Access Compliance Report

Public Rights-of-Way

Intersection ID: 30078	Main Street: SUNSET_RD	Cross Street: WOODLANDS_POINTE_DR	Location: NE
ADA ID: 4BB71C006742	Ramp Type: Perp	Initial Pass/Fail: Fail	Overall Compliance: No
		Severity Score: 1.25

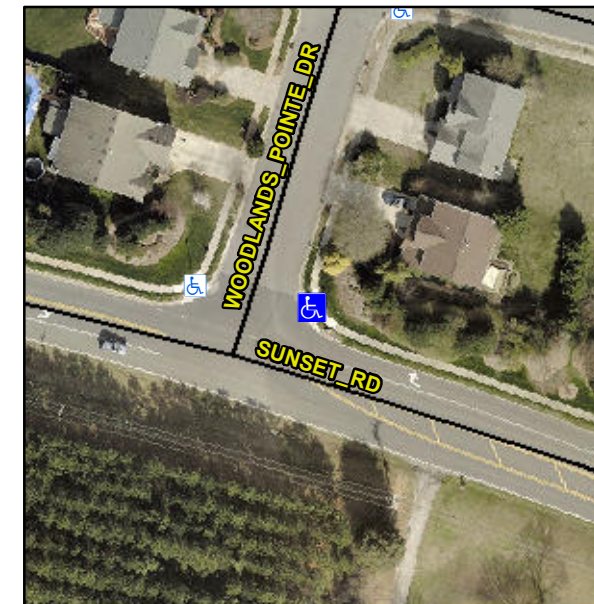
Not Found, R304.5.3

Compliance	Description	Data	Compliance	Description	Data
N/A	Ramp Length (in)	81.5	Yes	Ramp Slope (%)	8.0
Yes	Ramp Width (in)	48.0	No	Ramp XSlope (%)	4.5
N/A	Flare Type LT	N/A	N/A	Flare Type RT	N/A
N/A	Flare Slope LT (%)	N/A	N/A	Flare Slope RT (%)	N/A
N/A	Flare Traversable LT?	N/A	N/A	Flare Traversable RT?	N/A
N/A	Landing Length (in)	N/A	N/A	DWS Provided?	N/A
N/A	Landing Width (in)	N/A	N/A	DWS Contrast?	N/A
N/A	Landing Slope (%)	N/A	N/A	DWS Length (in)	N/A
N/A	Landing X Slope (%)	N/A	N/A	DWS Full Width?	N/A
N/A	Landing Curb? (Y/N)	N/A	N/A	DWS Offset (in)	N/A
N/A	Shared Landing?	N/A			
N/A	Gutter Ponding?	N/A	N/A	Gutter Slope (%)	N/A
N/A	Gutter Lip Ht (in)	N/A	N/A	Gutter X Slope (%)	N/A
N/A	Painted X Walk1?	No	N/A	Painted X Walk2?	N/A
	X Walk 1 Direction	To NW		X Walk 2 Direction	N/A
N/A	X Walk 1 Width (in)	N/A	N/A	X Walk 2 Width (in)	N/A
	X Walk 1 Slope (%)	0.2		X Walk 2 Slope (%)	N/A
	X Walk 1 X Slope (%)	7.9		X Walk 2 X Slope (%)	N/A

Remove & Replace Entire Ramp.
